NO. 00005 PAGE 1 OF 1

N17xx NuVinci HUB

Main Shaft

Change in Main Shaft and Shift Rod Nut Design

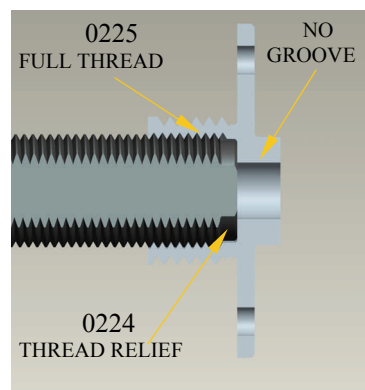
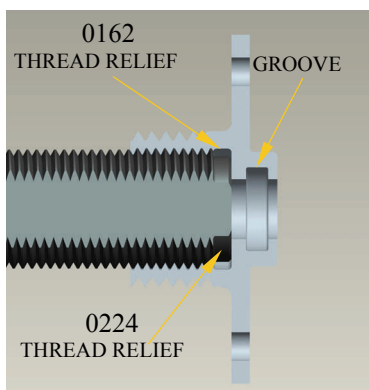
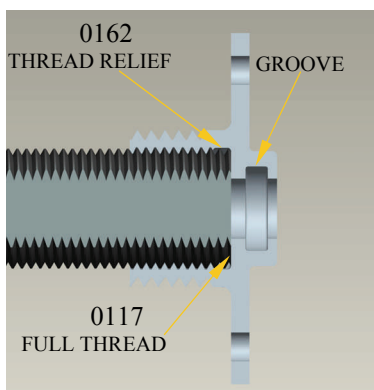
NUVINCI PART NO.	DESCRIPTION	SHIFT NUT INTERCHANGEABILITY
0117	MAINSHAFT	0162 only
0224	MAINSHAFT	0225, 0162

DO NOT USE 0225 SHIFT ROD NUT WITH 0117 MAIN-SHAFT. USE OF 0225 MAY RESULT IN IMPROPER TORQUE, SHIFT ROD END PLAY OR LEAK AROUND MAIN SHAFT.
